TO:MR. DAVID CROXTON
U.S. EPA, REGION 10
HW-106

FROM:ROBERT FARRELL

SUBJECT:PNOCO OIL SPILL, Pier 91-- REVIEW:
PRELIMINARY HYDROGEOLOGIC ASSESSMENT REPORT, NOV. 22, 1989;
PHASE I REMEDIAL INVESTIGATION, JANUARY 5, 1990;
PHASE I REMEDIAL INVESTIGATION, JULY 5, 1990;
INTERIM PRODUCT EXTRACTION SYSTEM, REMEDIAL ACTION PLAN, JULY 26
1990
ANNUAL PROGRESS REPORT, MARCH 5, 1992;

GROUND WATER
April 30, 1991

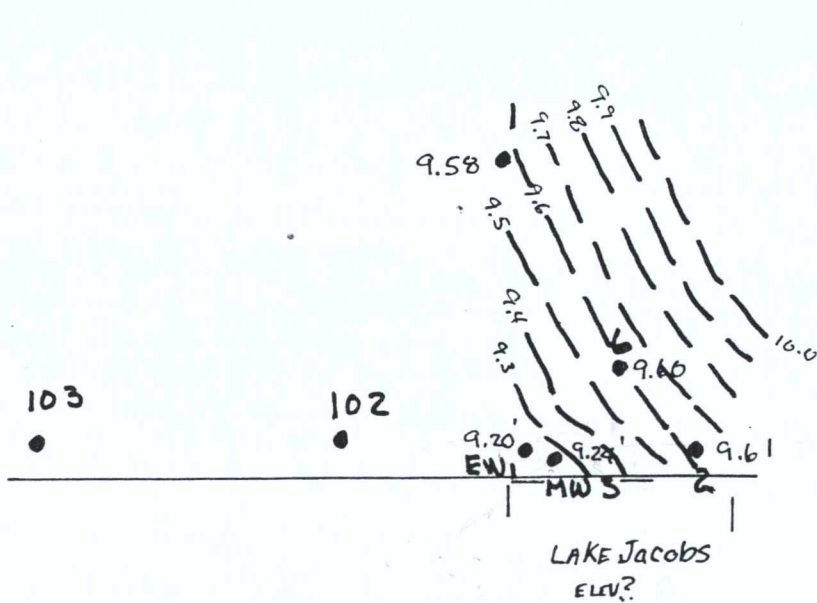
Close contouring of the available ground water data shown on figure 10 (April, 1991) and figure 11 (August, 1991) in the March 5, 1992 annual report indicates there is a discharge point through the bulkhead near wells MW-3 and EW-1. There is not enough data on the January 2, 1992 map to contour the direction of ground water flow. The available data for January 2 suggests there is a discharge point through the bulkhead further south than on the earlier maps. Whether this is because of a higher elevation in Lake Jacobs or is caused by some other reason is not known.

The ground water data from the most recent report of March 5, 1992, with EW-1 data, suggests the bulkheads on the east side of Pier 91 are not significant barriers to ground water flow. The presense of EW-1 near the bulkhead and MW-3 shows there is detail in water elevations and, therefore, ground water flow that is being missed because there are not sufficient observation wells used to draw ground water contour maps.

FIGURE 1

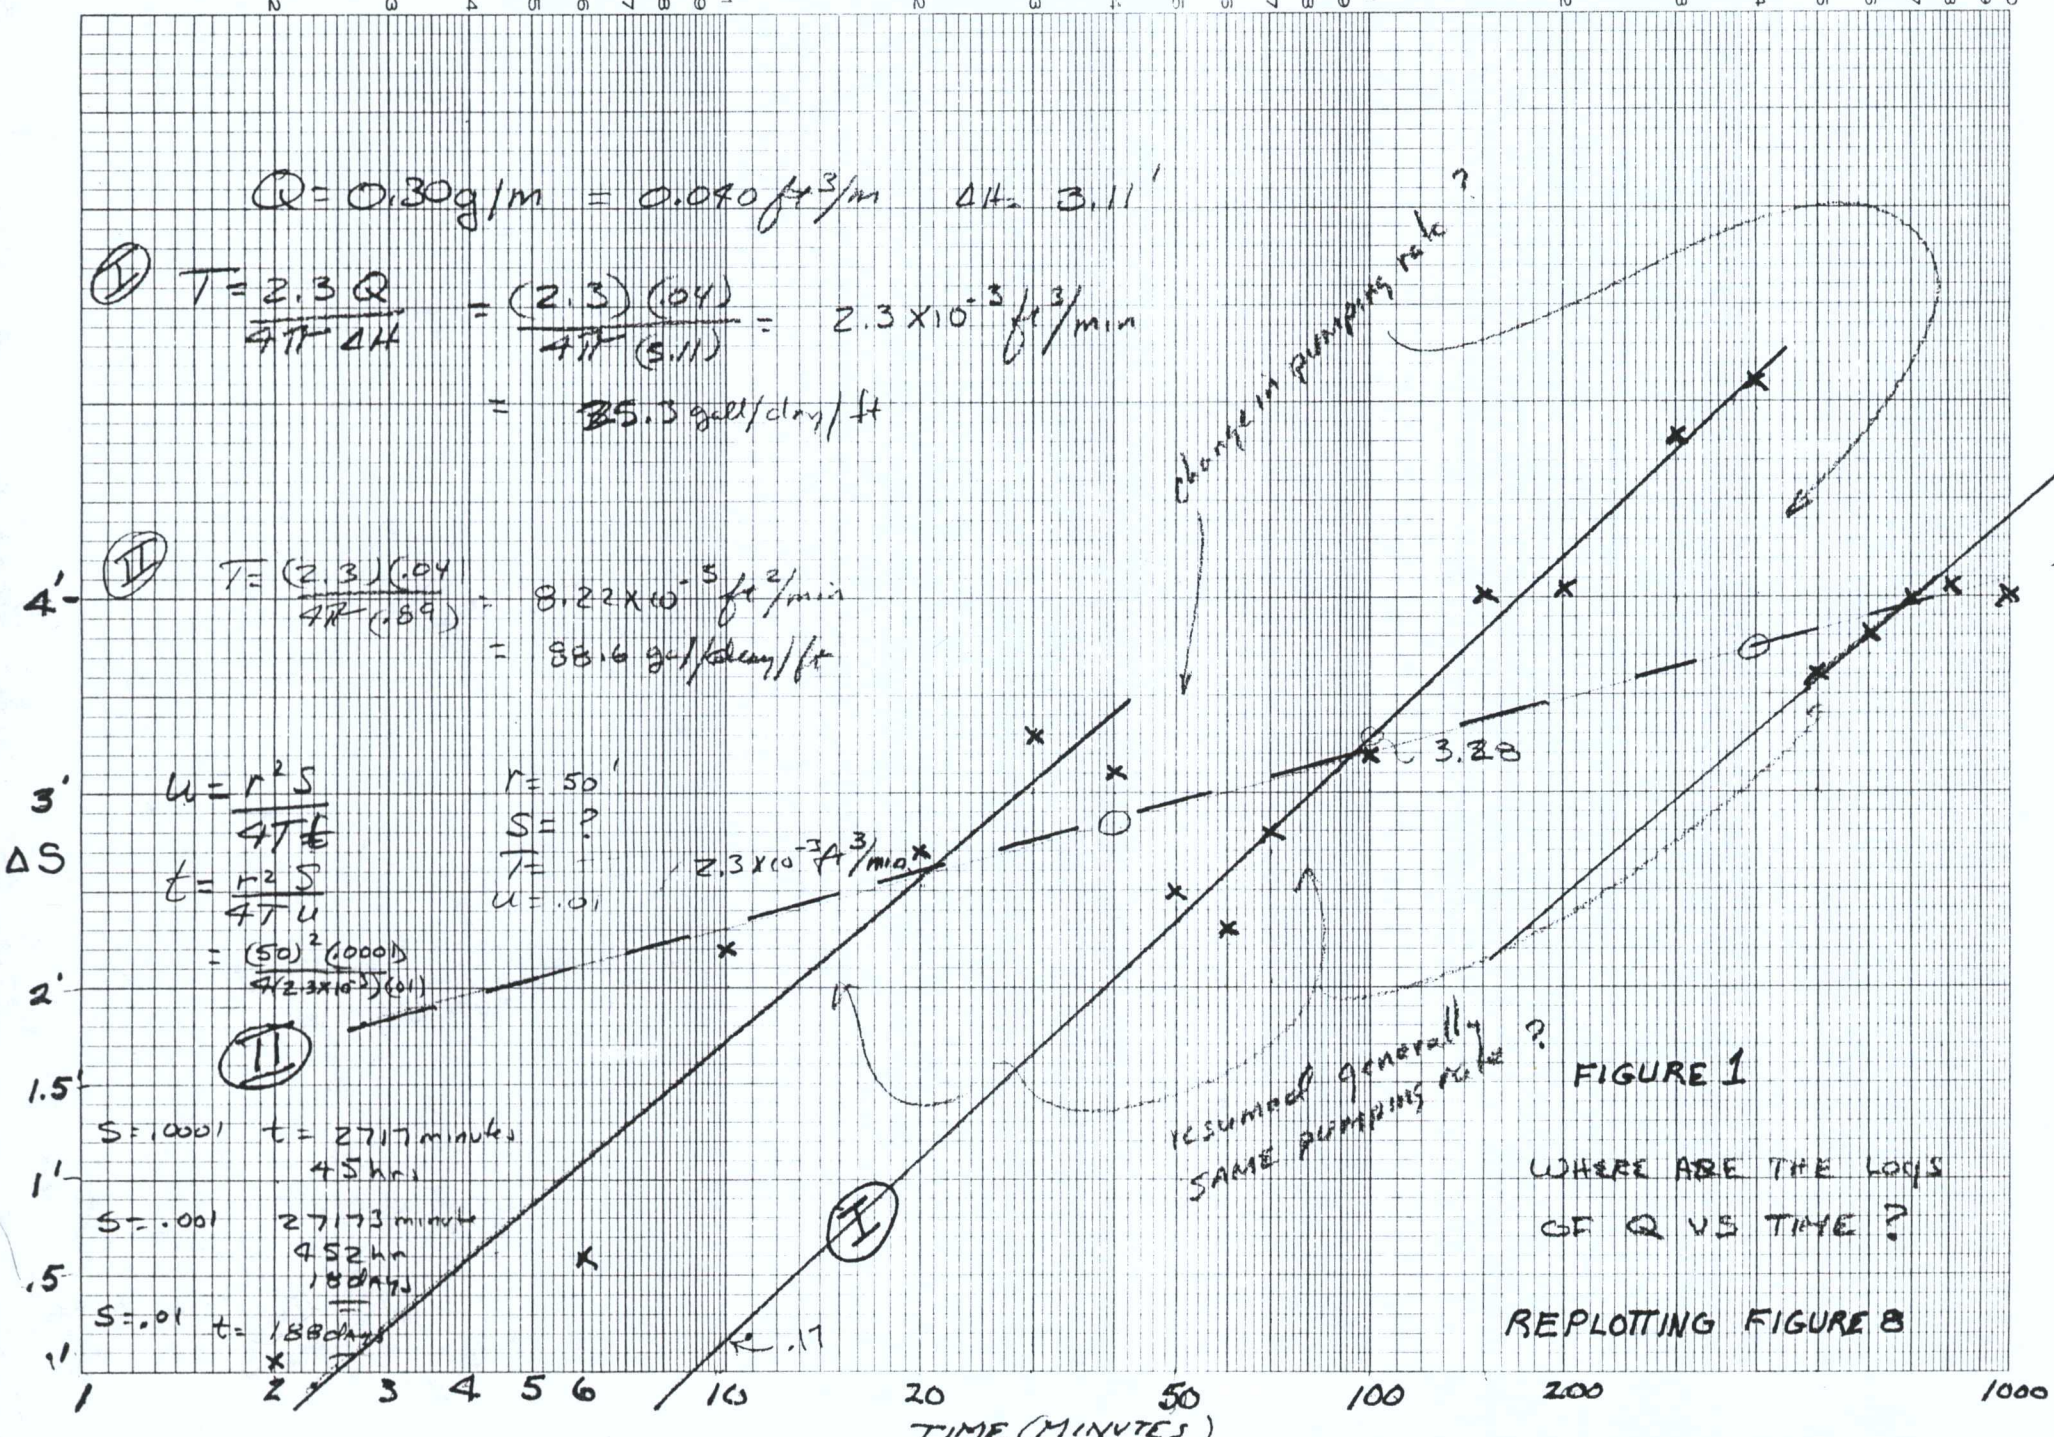
The data from figure 8 in the July 26, 1990 report for the pumping well MW-6 was replotted on semi-log paper (figure 1 attached). The data shows three breaks in the curve at about 40 minutes, 400 minutes, and some time after 1000 minutes into the test. Each of these breaks probably corresponds to changes in the pumping rate. In each case the pump rate appears to have returned to near its original rate. After each break the straight line continues to the next break. There is no evidence from the plot of the data that a recharge boundary or any other type of boundary was encountered during the pump test. Without a log of the pumping rate versus time taken during the test is not possible to determine if these breaks in the curve are really caused by changes in pumping rates or not. The transmissivities determined from these straight line segments would be at least an order of magnitude lower than the transmissivity that is suggested in the report. Interpreting this semi-log plot does not consider the effects of partial penetration of the pumping well nor the resulting vertical flow paths necessary to reach such a short well screen. As an example, the pump test indicates that the water level was lowered 4 feet in MW-6 during the pump test. The lowering of the water level by this amount changes the strata contributing water to the well from the sandy gravel to the gravelly sand/sand below it. If the hydraulic conductivity of these materials are significant, there should have been a corresponding change in the drawdown curve for the well. No corresponding change is recorded in the data. Further, if the transmissivity of the sediments is as low as suggested by either the semi-log plot or that suggested in the reports and assuming that the aquifer is a phreatic aquifer, it would take 18 days or longer to see a meaningful response at a monitoring well 50 feet away from the pumping well. If the aquifer is a phreatic aquifer, the effects of delayed yield would have to be factored into the amount of time necessary to obtain a meaningful drawdown curve. To observe these effects for such a small pumping rate as was used in this test would require the observation wells to be very close and the pumping well or the test would have to be carried out for a very long time. Neither of these conditions have been met by this pump test.

$$Q = 0.30 \text{ gal/m} = 0.040 \text{ ft}^3/\text{m} \quad \Delta H = 3.11'$$

$$\textcircled{I} \quad T = \frac{2.3 Q}{4\pi h \Delta H} = \frac{(2.3)(.04)}{4\pi(3.11)} = 2.3 \times 10^{-3} \text{ ft}^3/\text{min}$$

$$\textcircled{II} \quad T = \frac{(2.3)(.04)}{4\pi(.89)} = 8.22 \times 10^{-5} \text{ ft}^2/\text{min}$$

WHERE ARE THE LOGS
OF Q VS TIME?

REPLOTTING FIGURE 8
